**CITY OF BATON ROUGE  
PARISH OF EAST BATON ROUGE  
DEPARTMENT OF ENVIRONMENTAL SERVICES**

**ADDENDUM NO. 5**

**SUBJECT:** FLORIDA BOULEVARD PUMP STATION IMPROVEMENTS  
CITY-PARISH PROJECT NO. 11-PS-MS-0003

FLORIDA BOULEVARD PUMP  
STATION IMPROVEMENTS  
PUMPING STATION 101  
TIE-IN COORDINATION PLAN

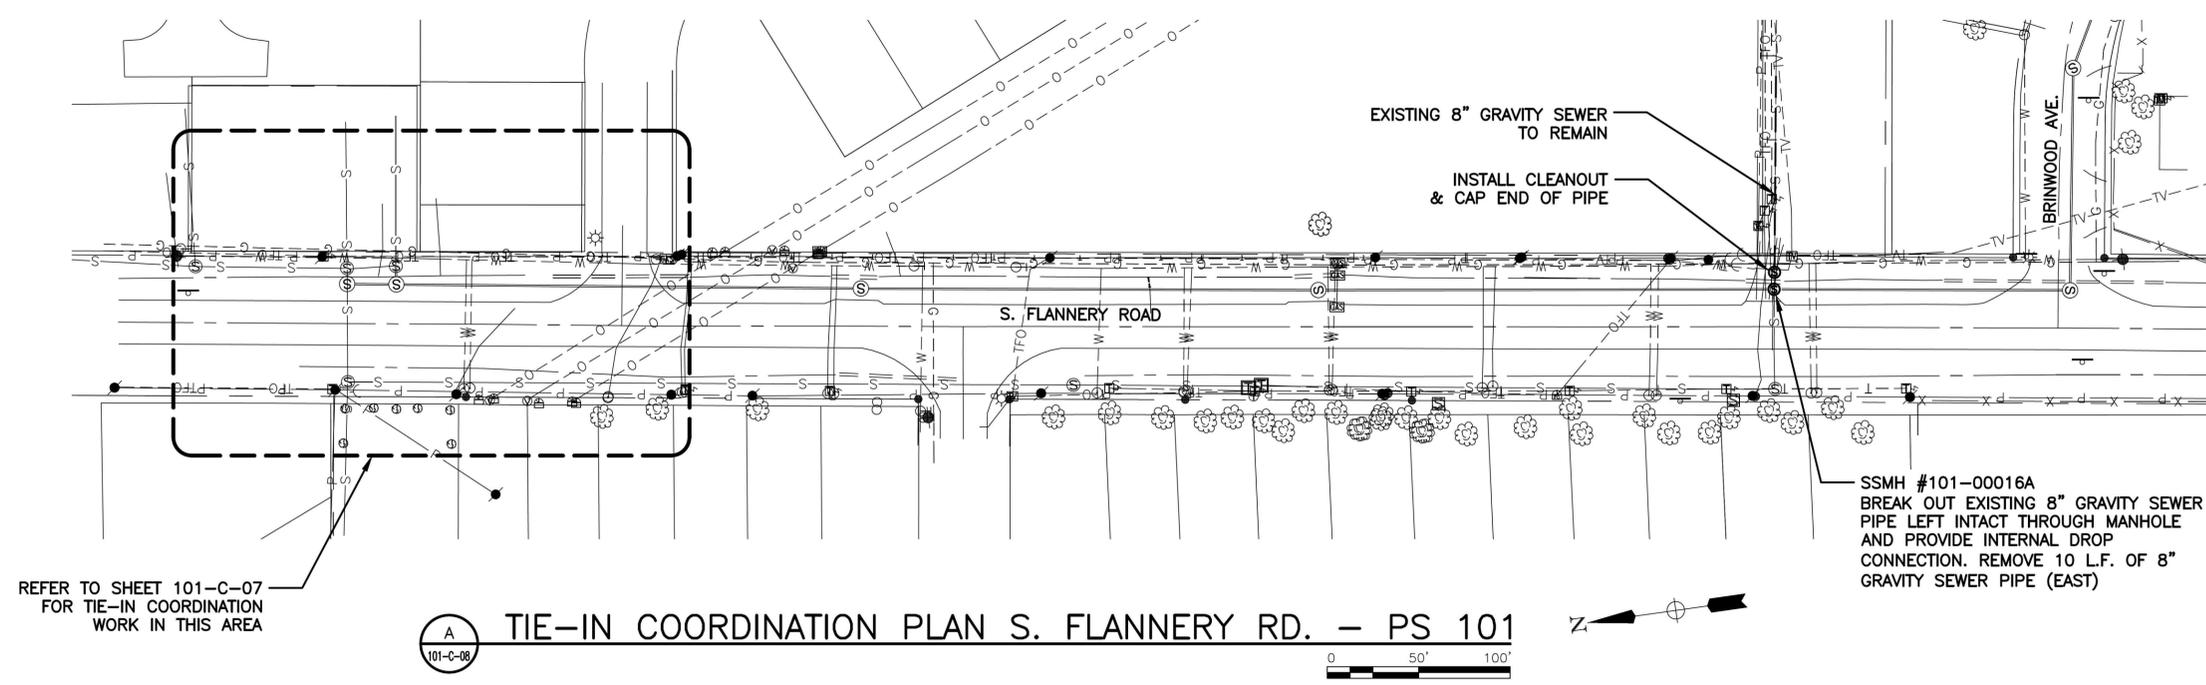
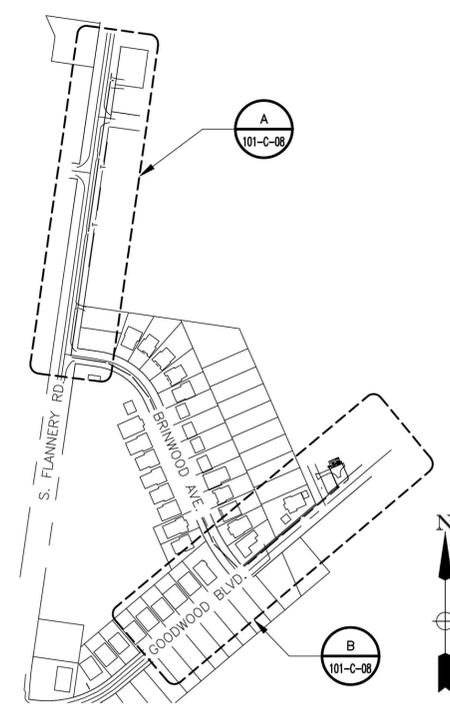
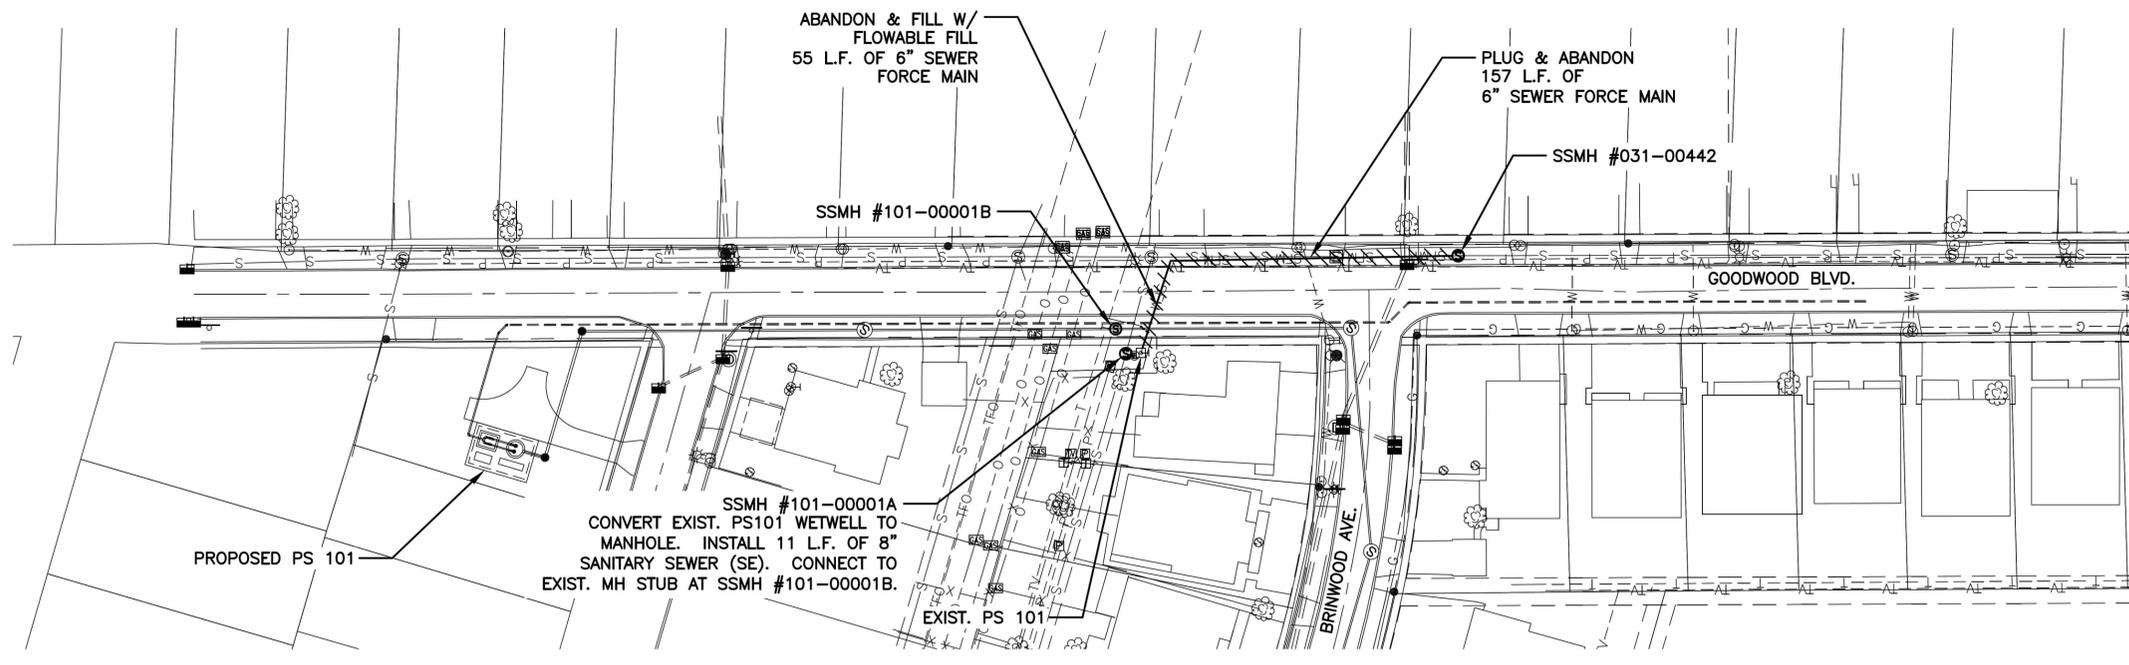
1. Insert attached Sheet No. 101-C-08.
2. Sheet 101-C-02, Demolition Plan – Existing PS 101, Delete callout for existing sanitary north of PS 101 and Replace with “Existing Sewer Line to Remain”.
3. Sheet 101-C-02, Add Note 11 as follows:

1  
311-E-01 **PS 311 PUMP CONTROL PANEL MODIFICATION TO ADD AUTOMATIC TRANSFER SWITCH**  
NOT TO SCALE

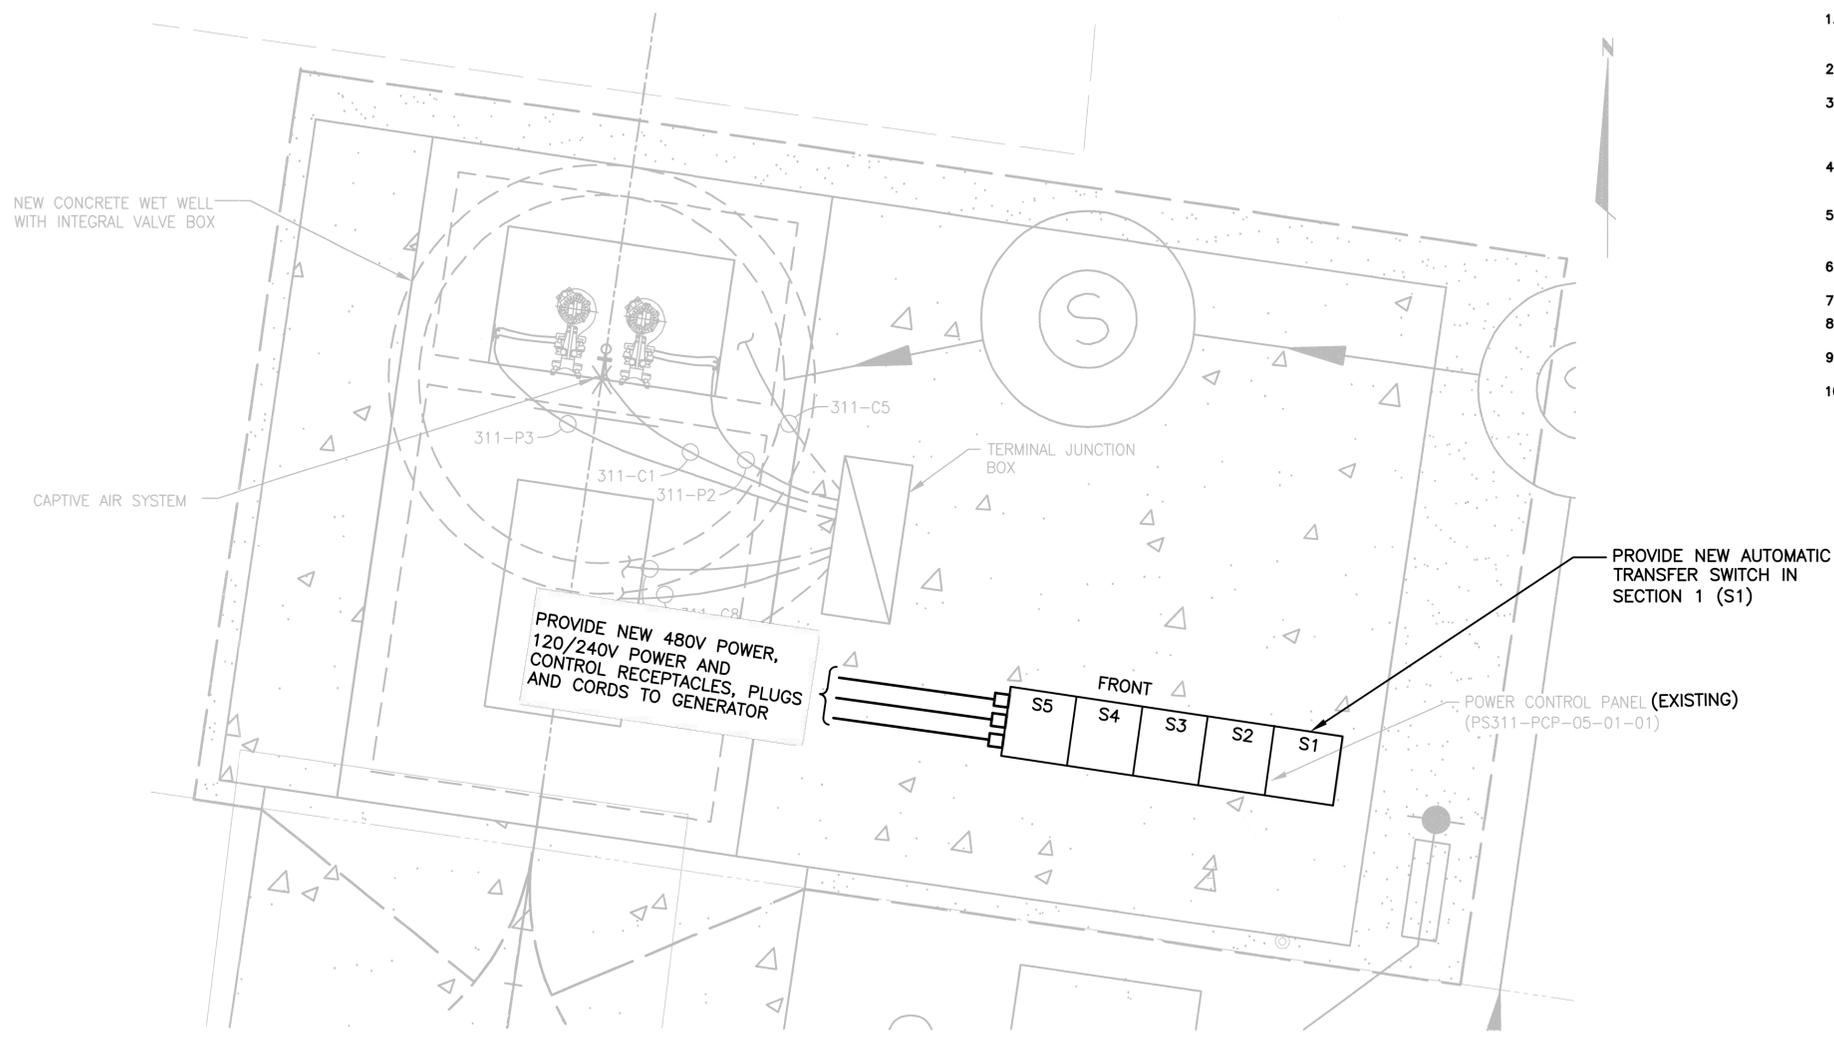
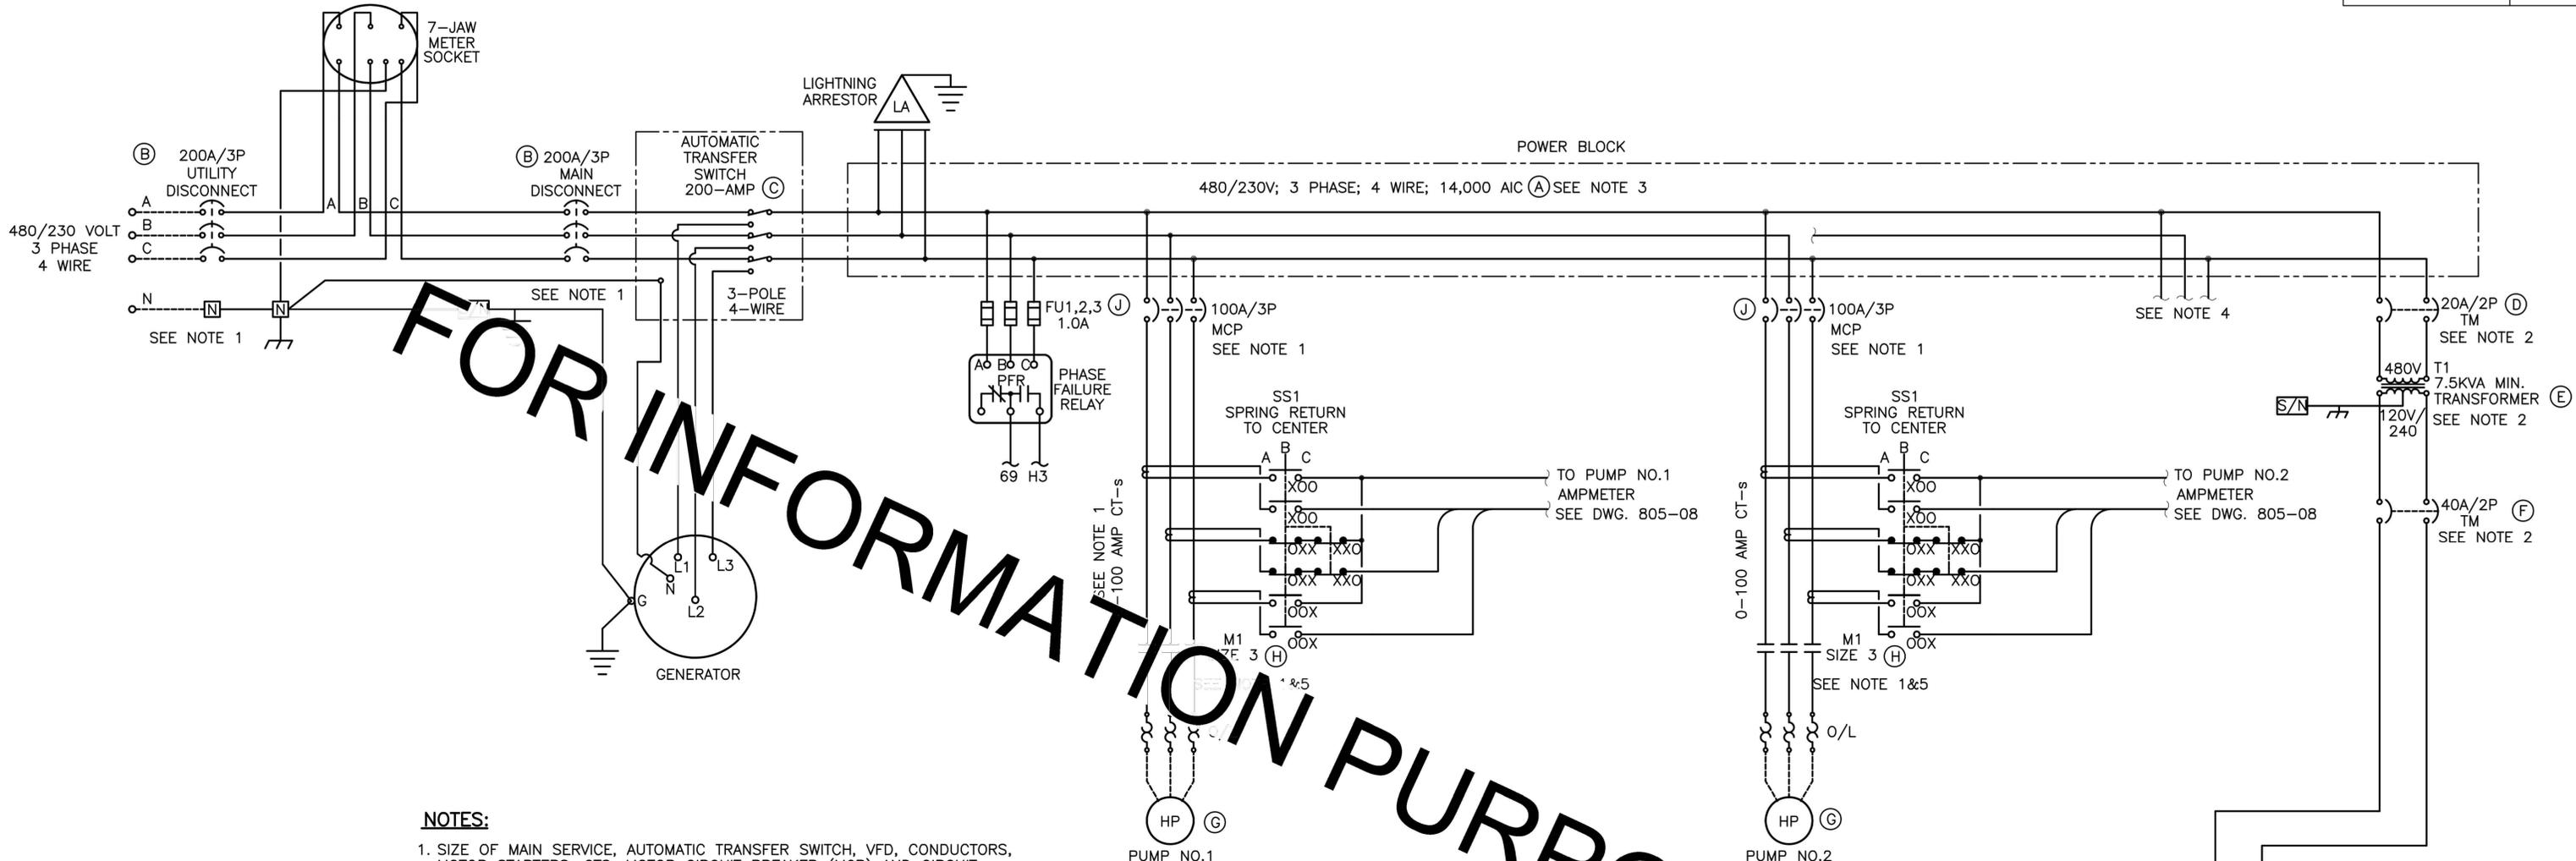
Existing wet well shall be converted to manhole. Remove top three (3) feet as shown and replace with new cone, frame and cover in accordance with Section 803. Fill with 4000 psi concrete to existing invert elevation 26.3 (field verify) and form invert. Concrete and invert shall meet the requirements of Section 803.
4. Insert attached Sheet Nos. 311-E-01, 311-E-02, and 311-E-03.
5. Insert attached Sheet Nos. 336-E-01, 336-E-02, and 336-E-03.
